In re: W280EL, Yates, MI
BPFT-20160128BEN
Facility ID No. 156357

This letter refers to the above-captioned modification application.

Fill-in review of BPFT-20160128BEN:

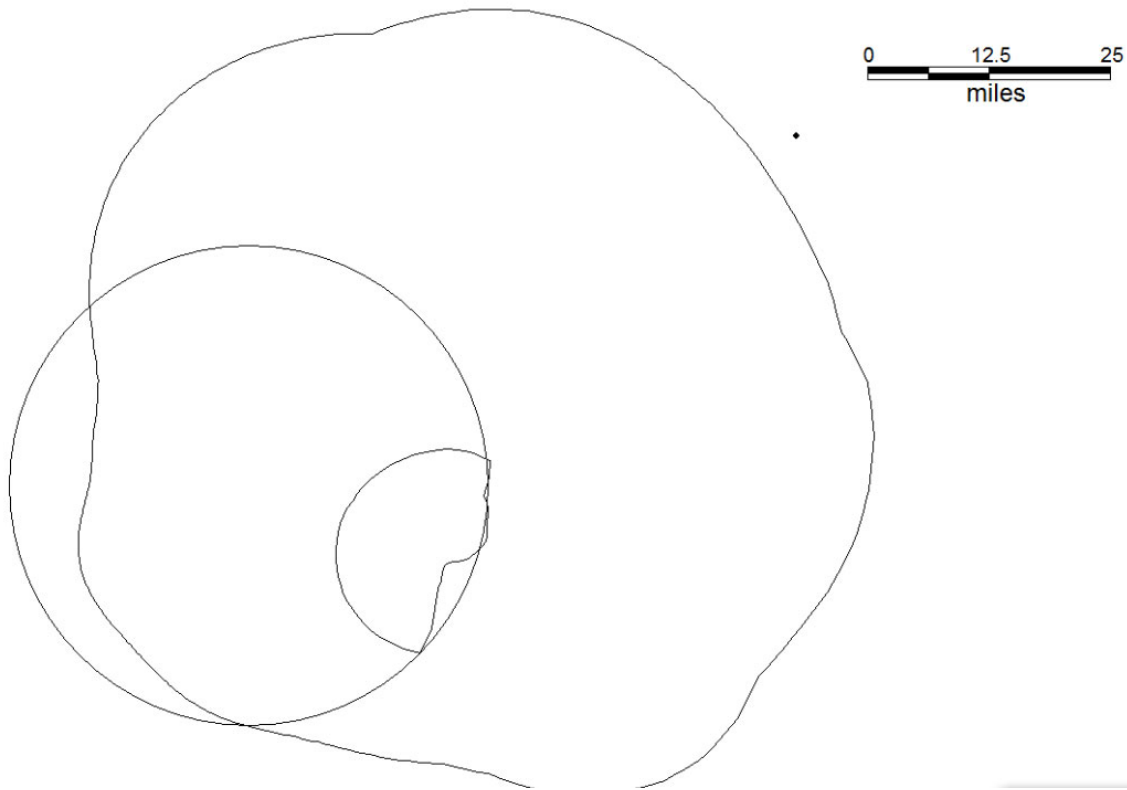
Our study of the application reveals that it is in violation of Section 74.1201(g) of the Commission's Rules. Section 74.1201(g) states that the coverage contour of an FM translator rebroadcasting an AM radio broadcast station must be contained within the lesser of the 2 mV/m daytime contour of the AM station and a 25-mile (40 km) radius centered at the AM transmitter site. The proposed coverage contour (60 dBu) of the translator is not contained within the 25-mile (40 km) radius centered at WCXI(AM)'s construction permit transmitter site. See next page. This was not addressed in the application.

In light of the above, the application BPFT-20160128BEN is unacceptable for filing pursuant to 47 C.F.R. § 73.3566(a) and IS HEREBY DISMISSED. This action is taken pursuant to 47 C.F.R. § 0.283.
